ADDENDUM NO. 1
November 18, 2011

Project: **City Hall Public Restrooms**
 Sausalito, California
 Don Olsen Architects

From: Loren Umbertis
 Division Manager, Public Works
 Sausalito, CA 94965

A0.0

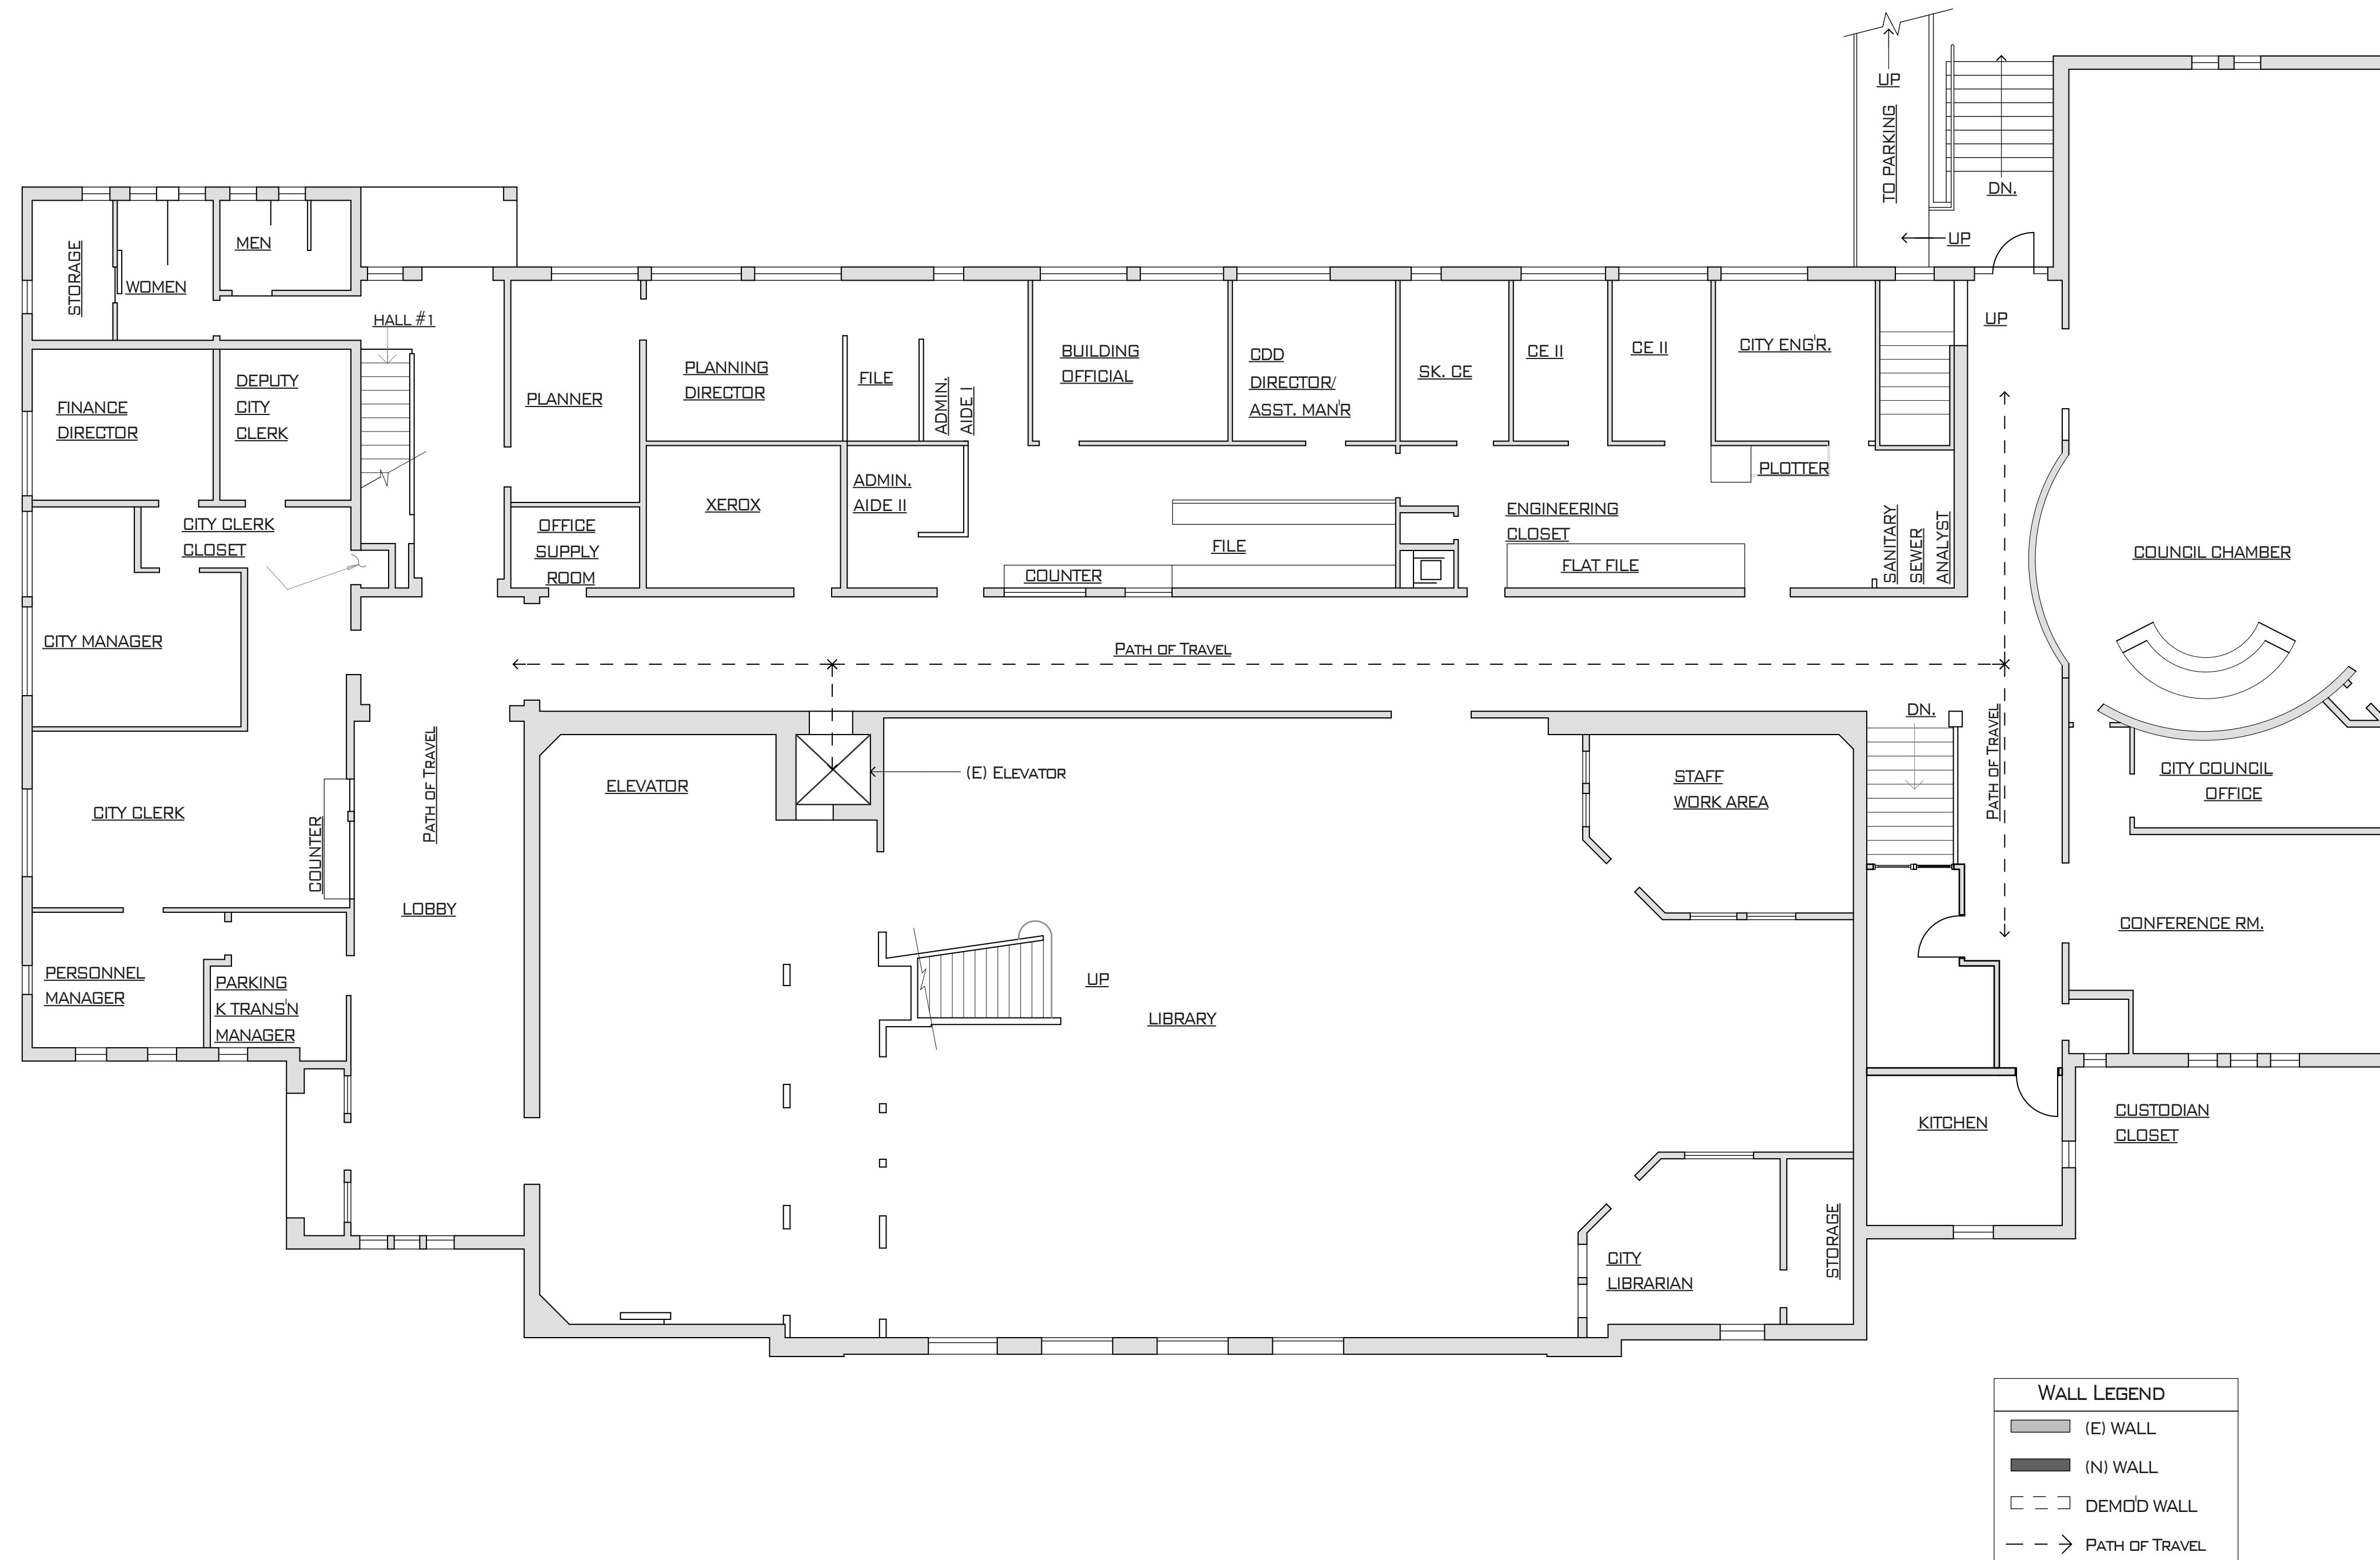
6. Drawing Sheet A0.0 – Construction Management Plan, note #3 – Hours of Operation are 8 a.m to 6 p.m. Monday through Friday and 9:00 a.m. to 5 p.m. on Saturdays. Now work will be allowed on Sundays or Holidays.
7. Contractor shall disregard comments referencing Radiant Heating in Drawings, and shall not include bids or pricing for Radiant Heating in the Drawings.
8. Contractor shall review drawings for any and all changes to the Project, and any changes shall be understood and agreed upon to be included in Bid Price

A4.0

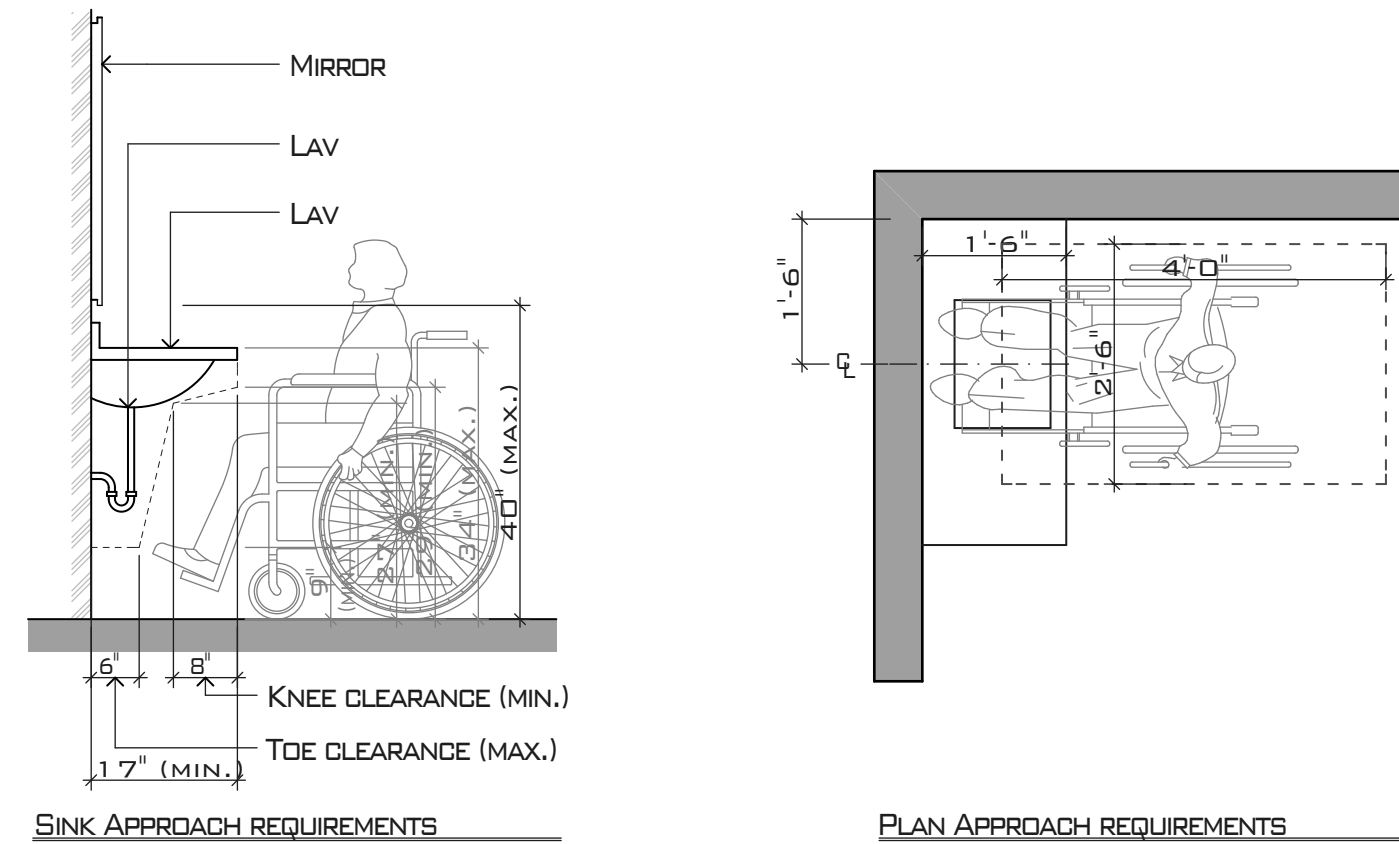
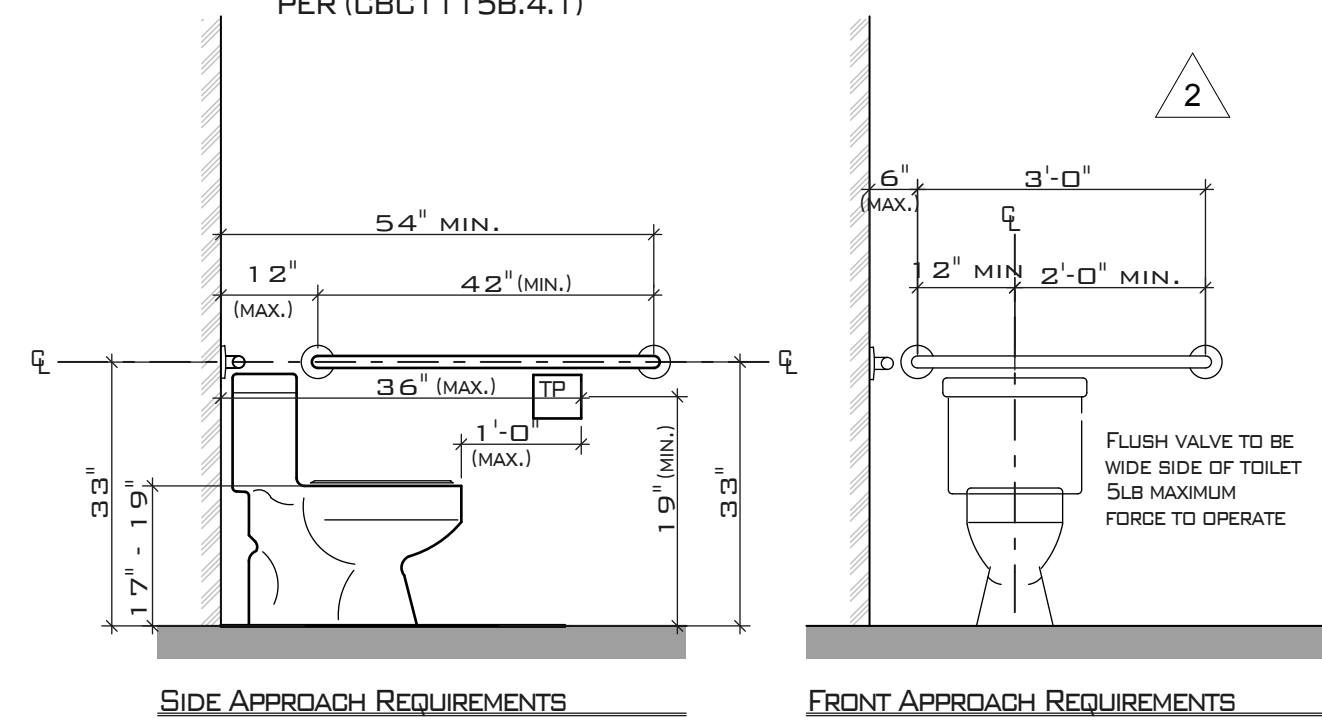
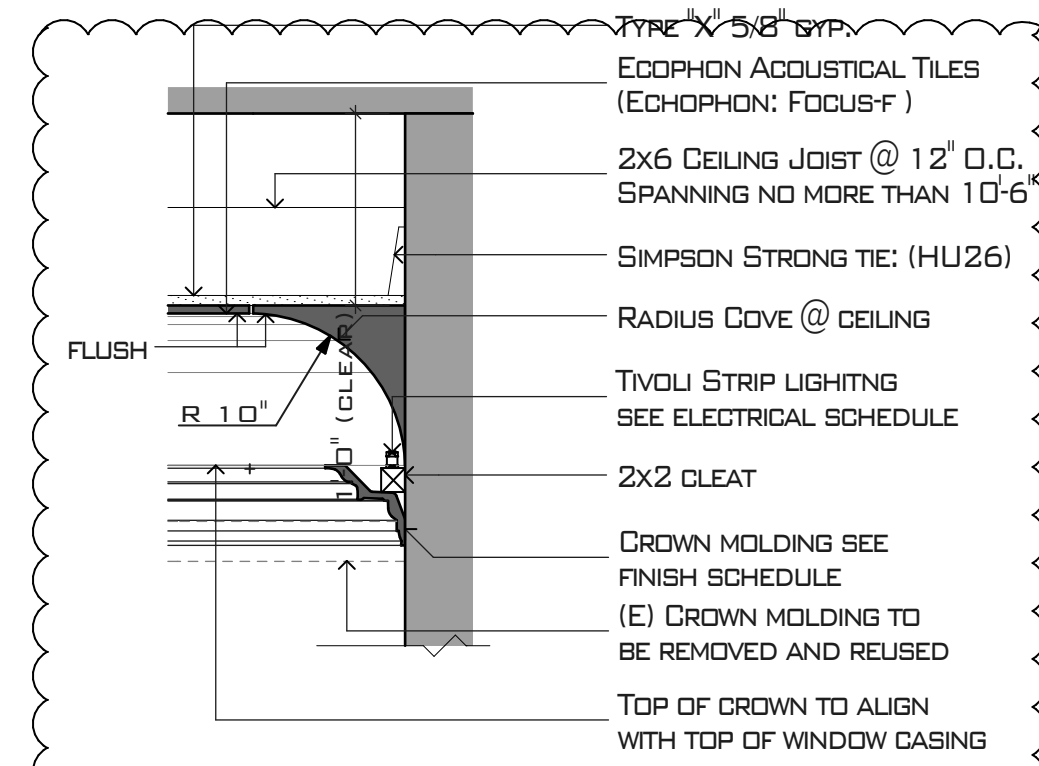
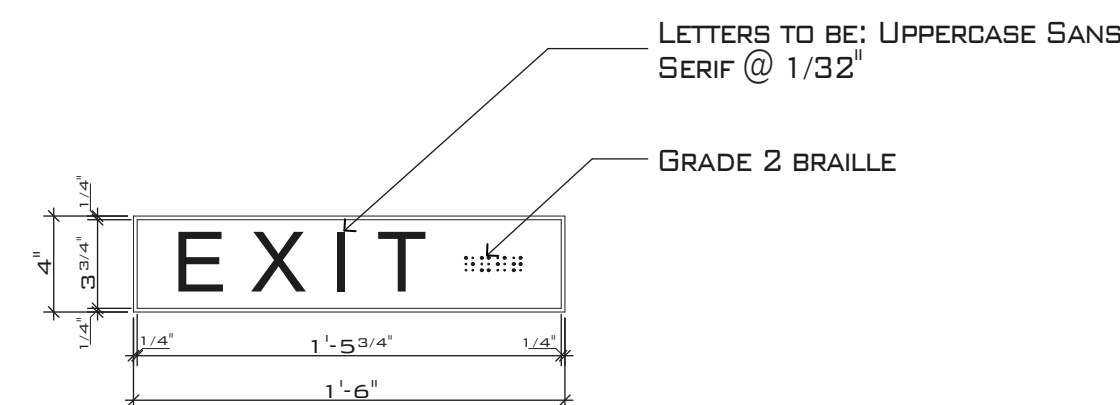
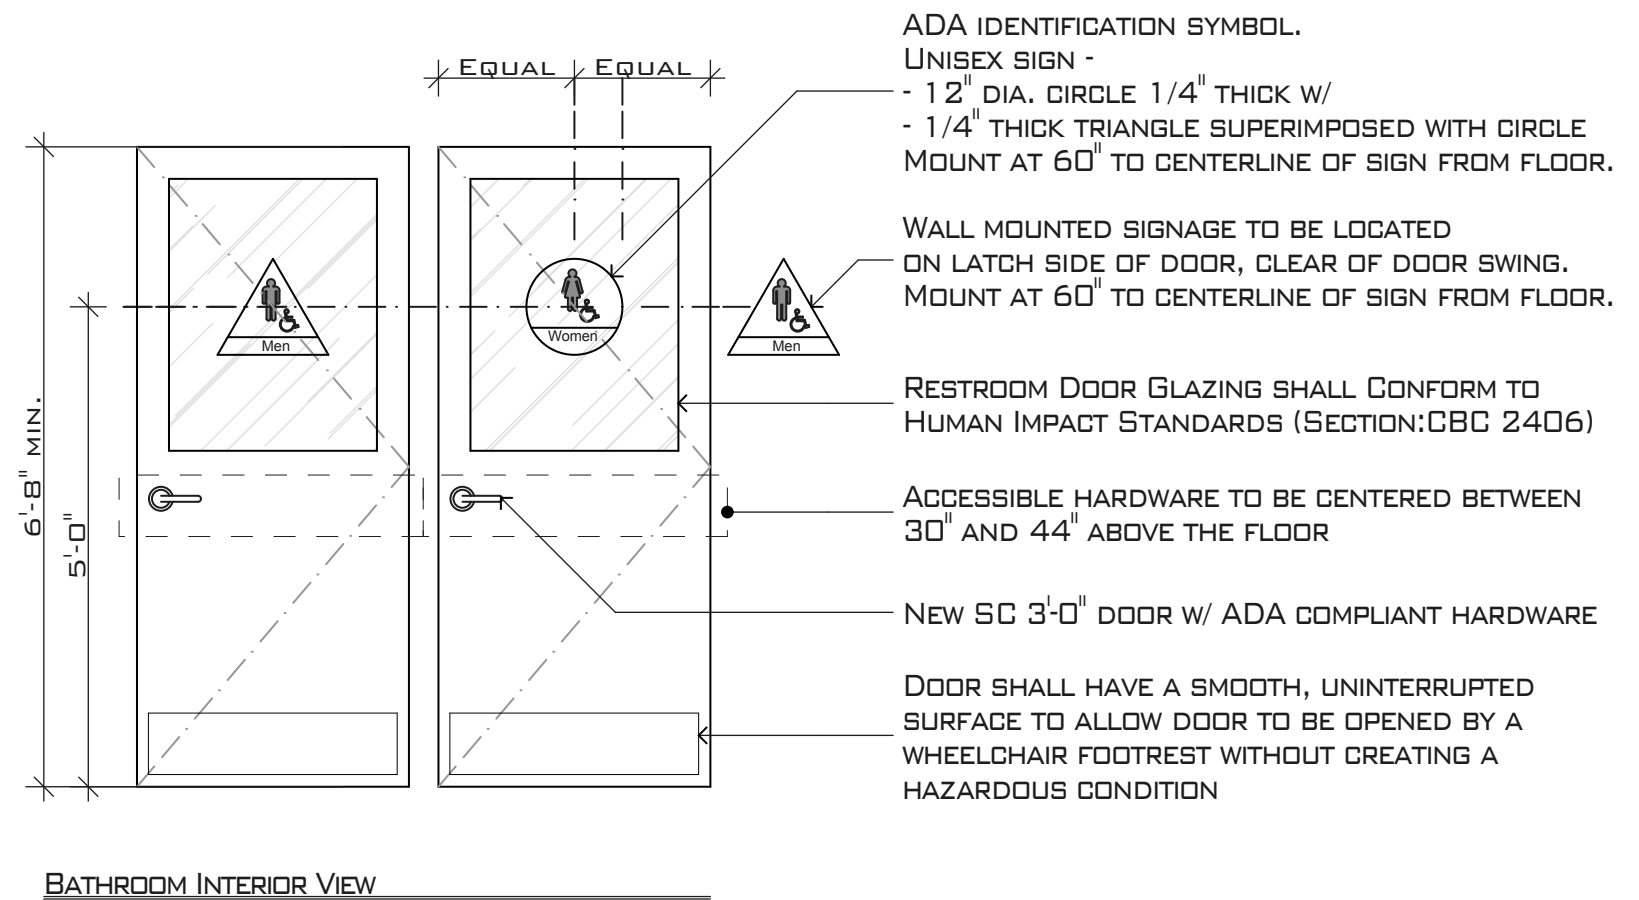
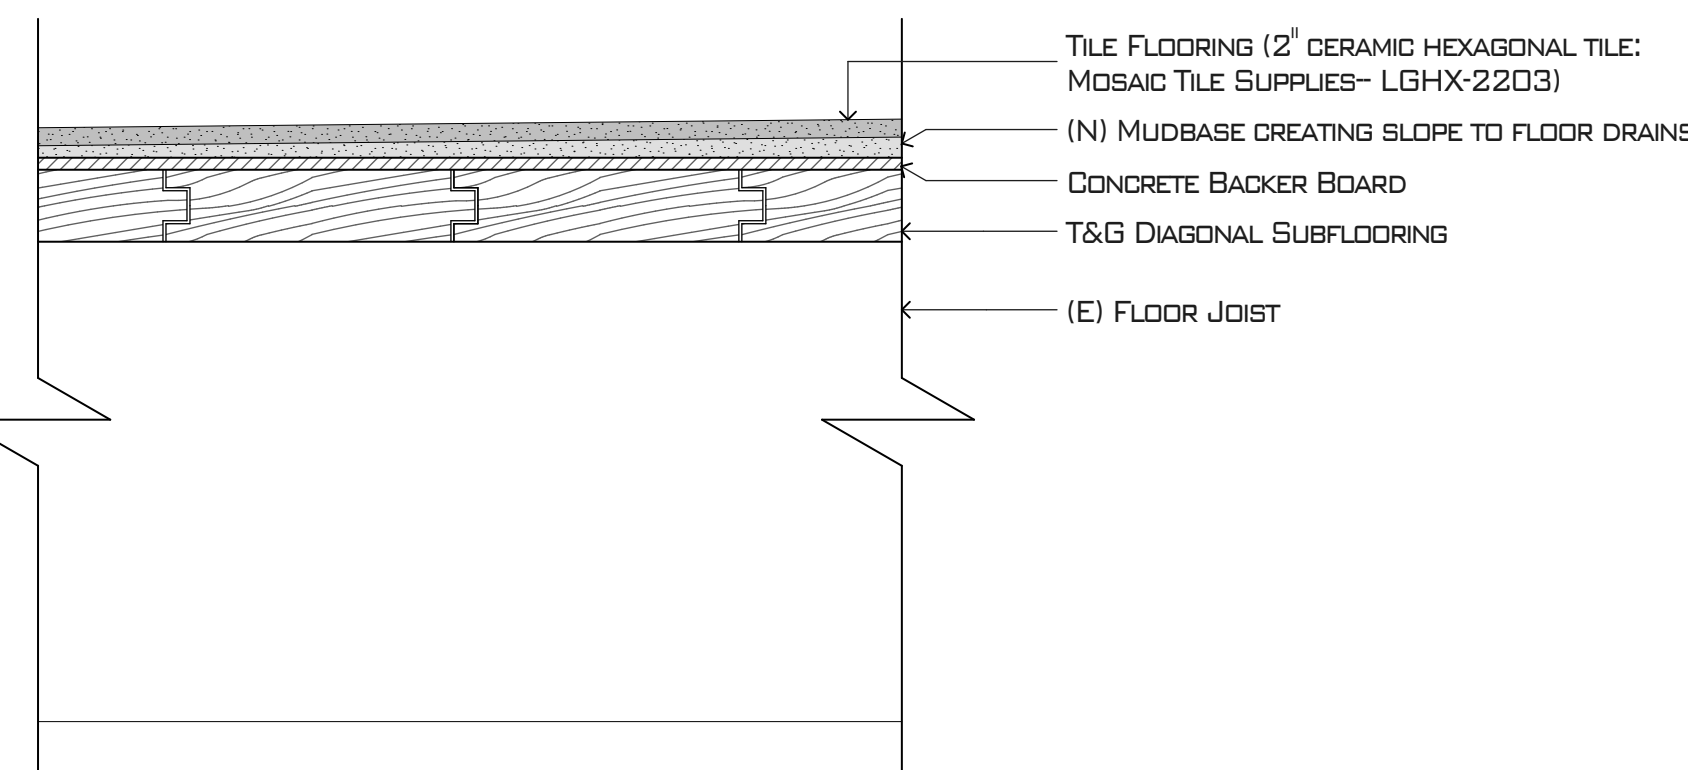
10. **Q: Additional Details regarding flooring are necessary. Will they be included?** A: Additional details regarding the flooring are now included on Sheet A4.0
